DATE: July 11, 2025
RE: **Clarendon Hill Thoroughfares Revision Narrative**
FROM: Kendra Halliwell and Tim Synan, ICON Architecture

The total redevelopment of Somerville Housing Authority's Clarendon Hill will include up to 591 new and replacement housing units, common space, public roadways and central park, and the improvement of the intersection at Powderhouse and Alewife Brook Parkway.

CLARENDON HILL
SOMERVILLE, MASSACHUSETTS

PROPOSED

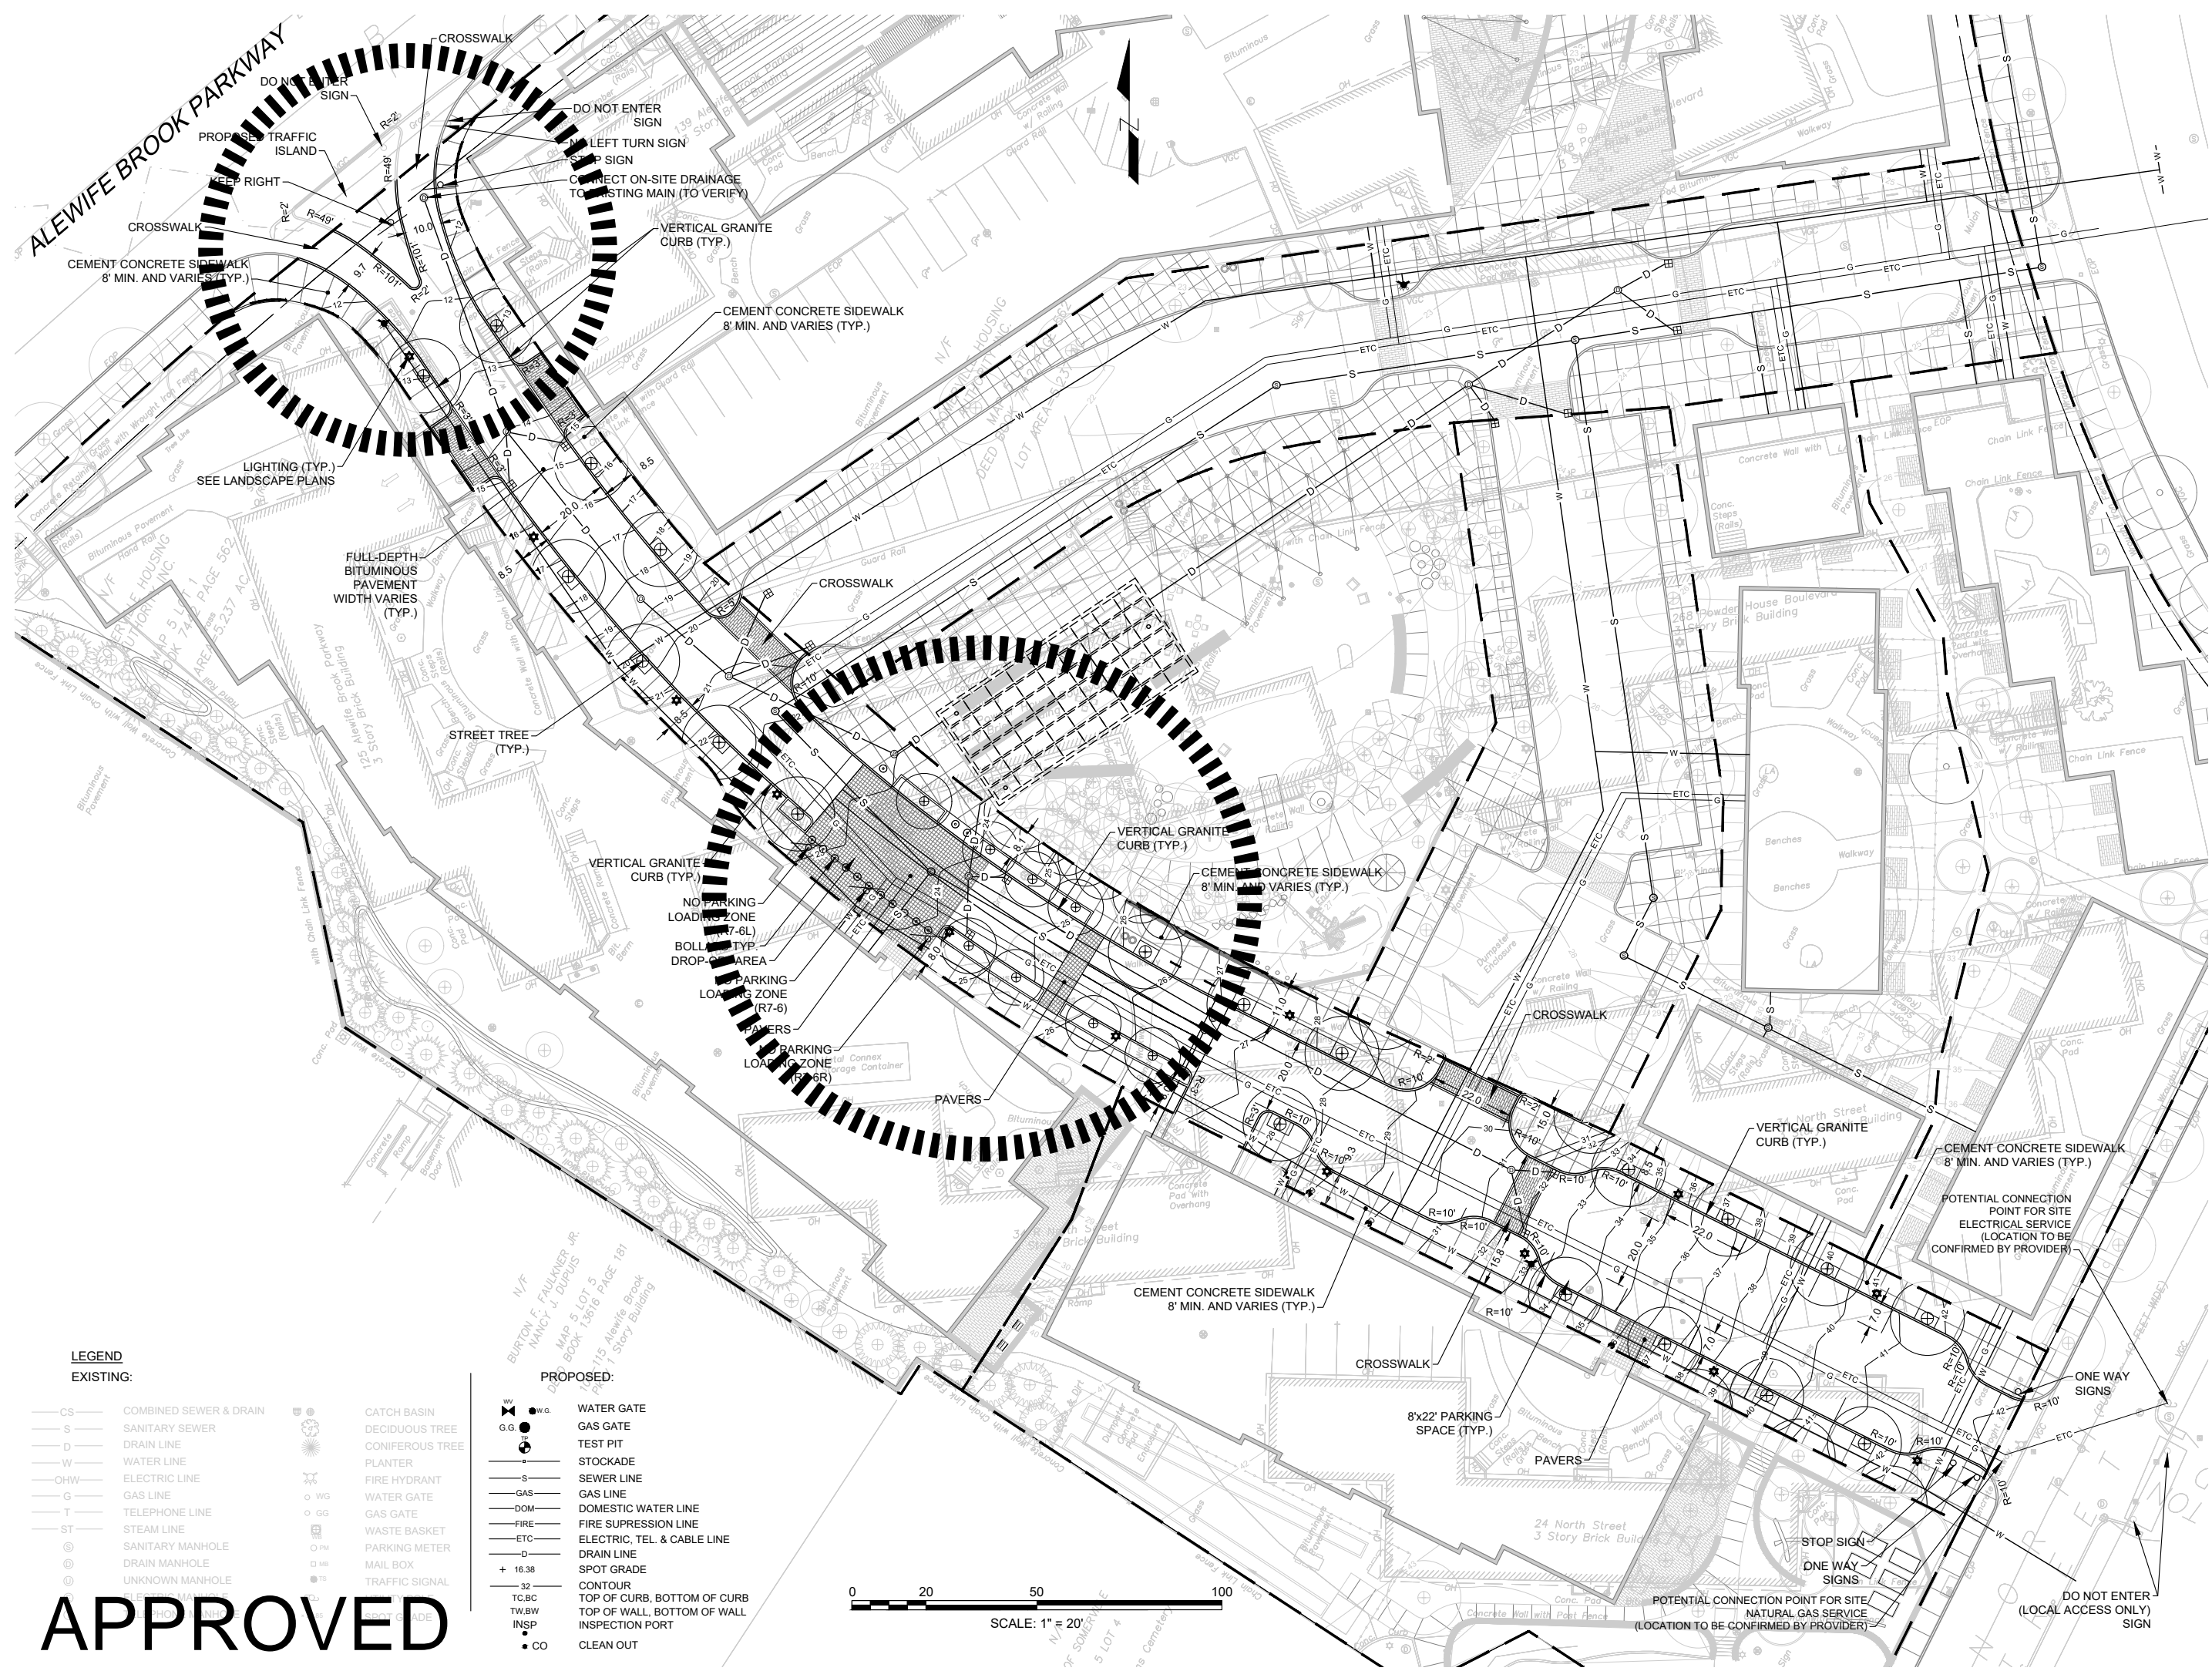
- Alewife Brook Parkway at Stephenson Aman Street, added raised crosswalk added and removed island.
- Typical corner crossings will be city standard thermoplastic striped paint, and the woonerf paving will be vehicle-grade concrete paving (phase 2).
- Bike racks are relocated from furnishing zone onto private property.

- Street Tree Pit Relocation: Adjacent to the woonerf (phase 2) a tree has been relocated and bike rack shifted, to avoid conflict with curb ramp.
 - Planting area: Removed from park side of crossing, and added planting edging near Building E entrance.

- Rain garden area: Combined with phase 2 rain garden in civic space.
4. Signage/stripping:
- No parking zone to be provided in the surface parking lot adjacent to the crosswalk. There should be signs and pavement striping defining no parking in this area.

L-102

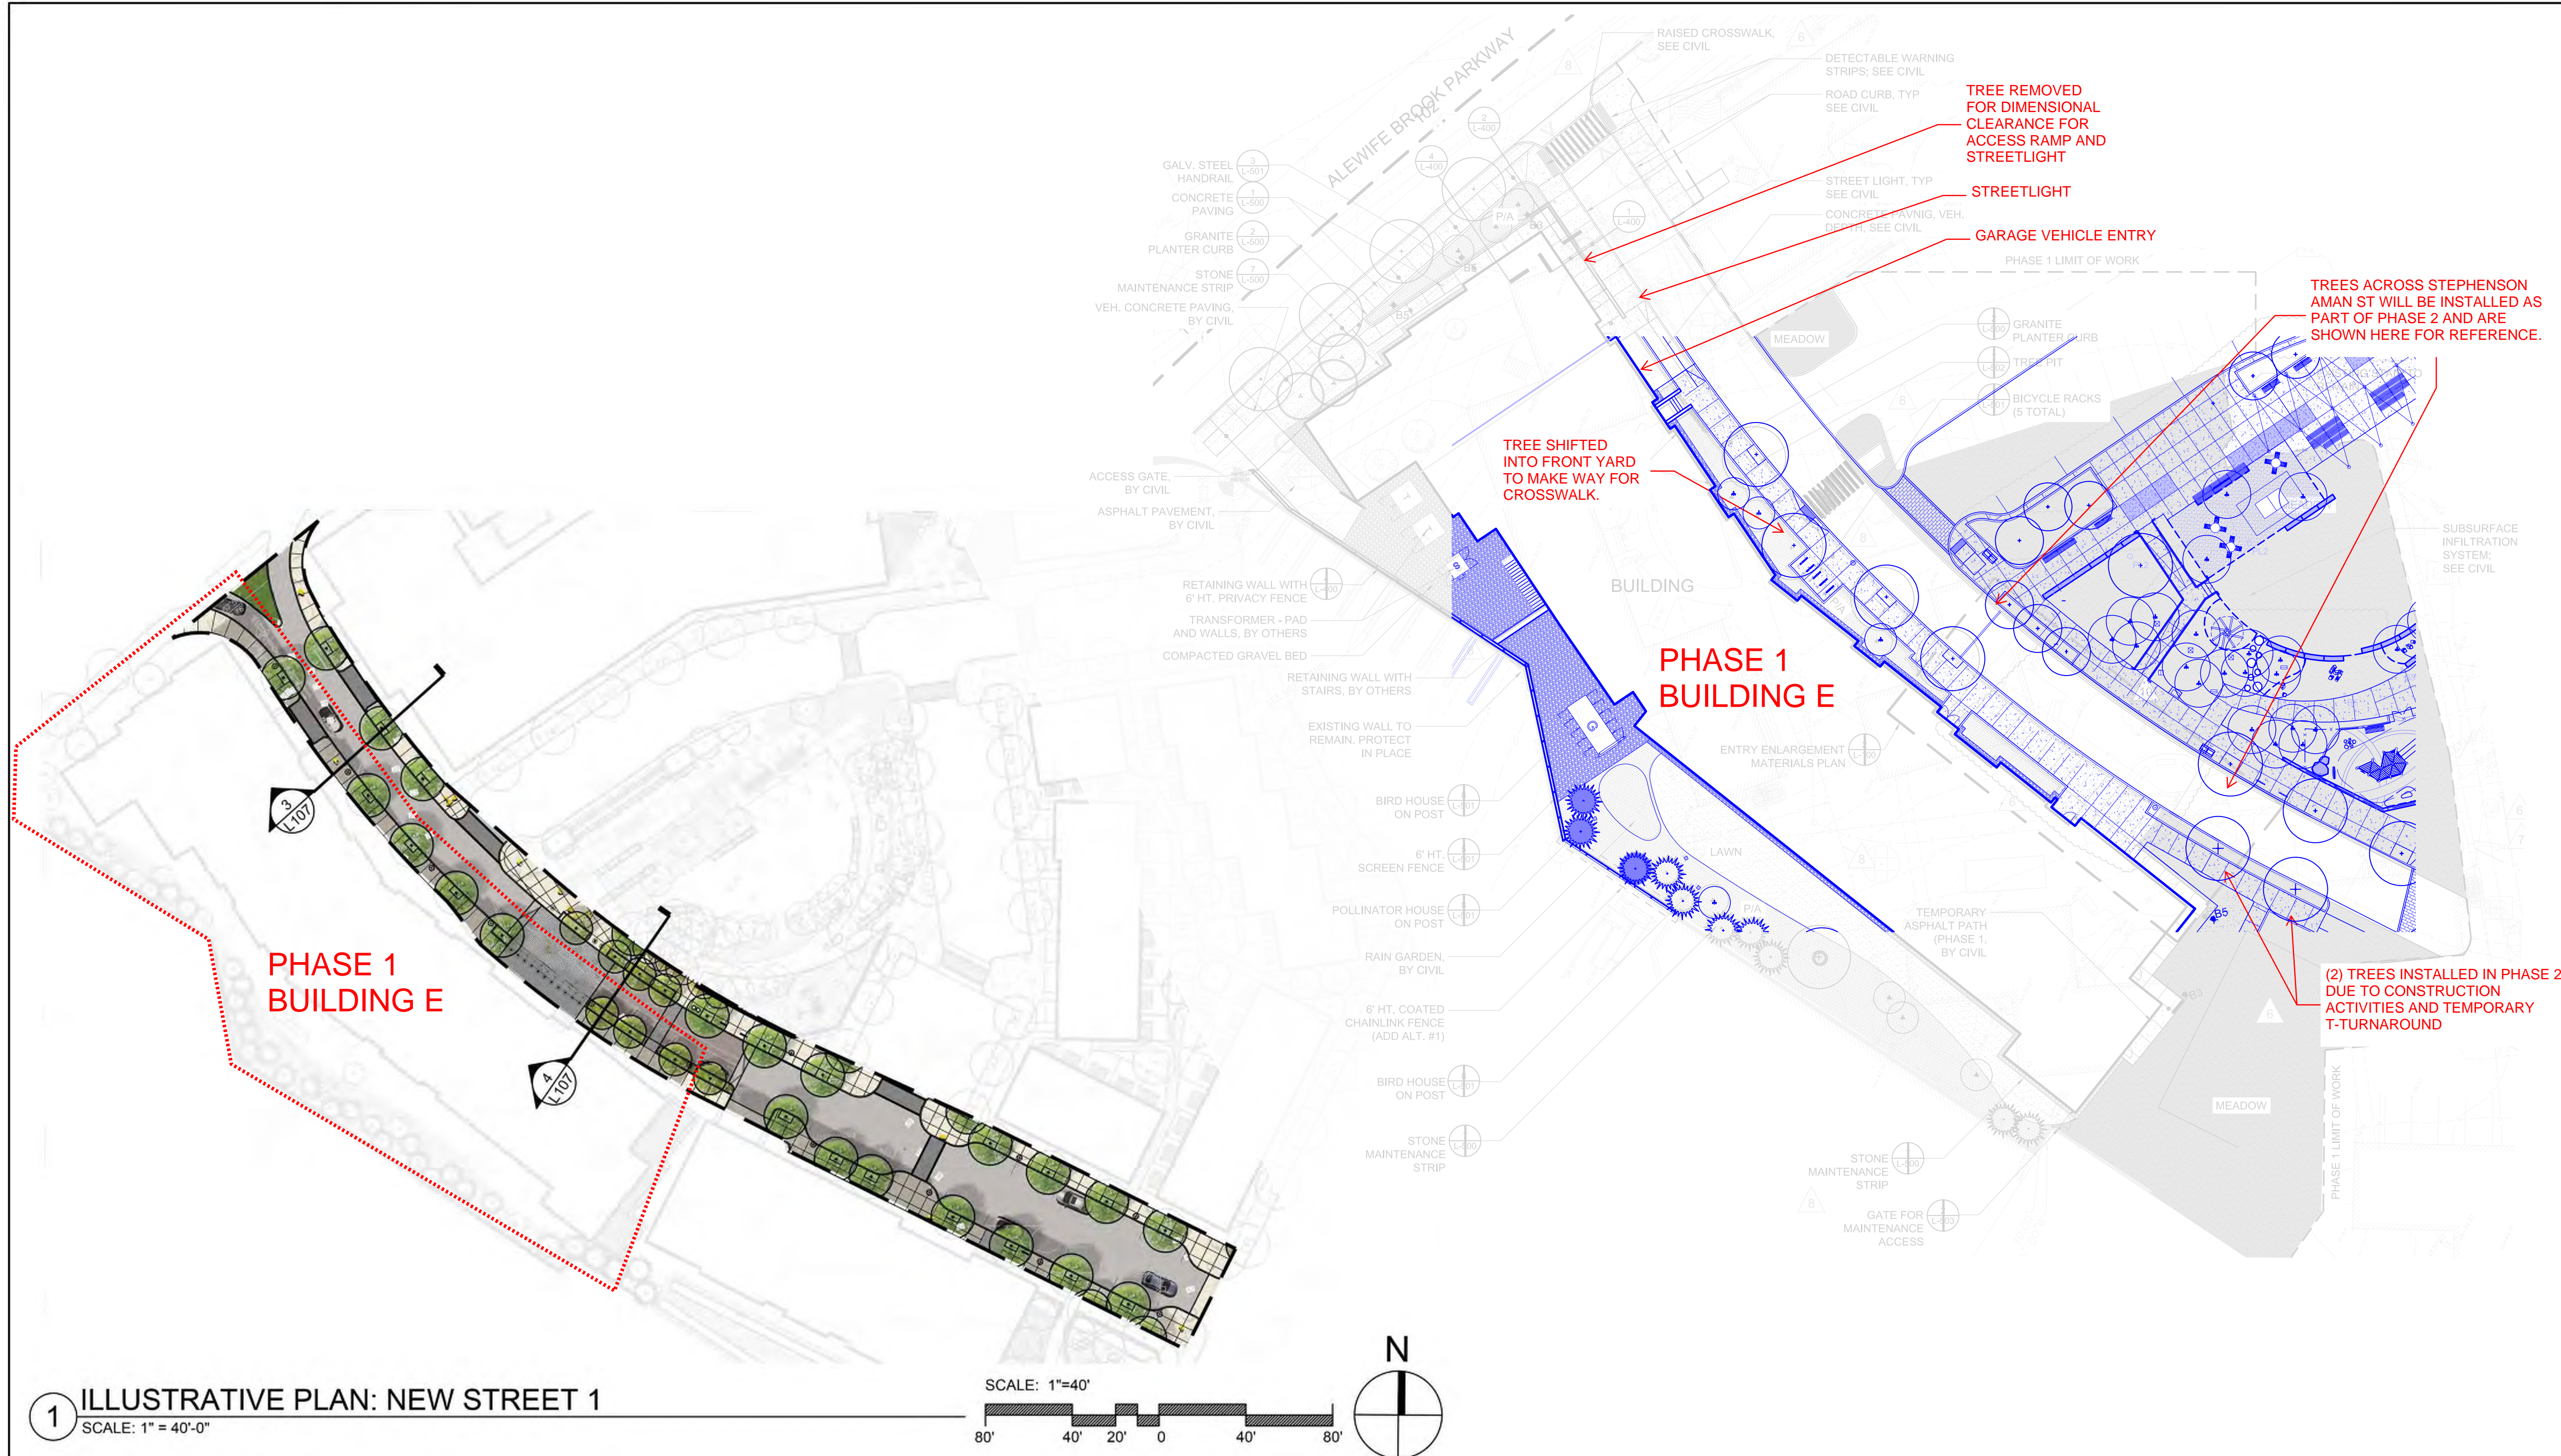
- Trees at regular spacing (35-45' apart): The spacing and quantity was reviewed with PSUF.

- Street trees: The streets within this development are all new and therefore, there were zero street trees to reduce/remove. The illustrative plan shown in the masterplan was showing the intent to have street trees. Those early plans were not fully developed and required many additional elements, including grading, crosswalks, bicycle spaces, etc to make the design fully functional. In total: there will be 6 total trees included at phase 1, 4 at the time of phase 1 completion and 2 being installed after phase 2 is completed due to concerns for damage and logistics.

APPROVED
(PHASE 1= 8 TREES)

(PHASE 1= 4 TREES, AS
DISCUSSED WITH PSUF, 2
ADDITIONAL INSTALLED
POST PHASE 2
CONSTRUCTION)
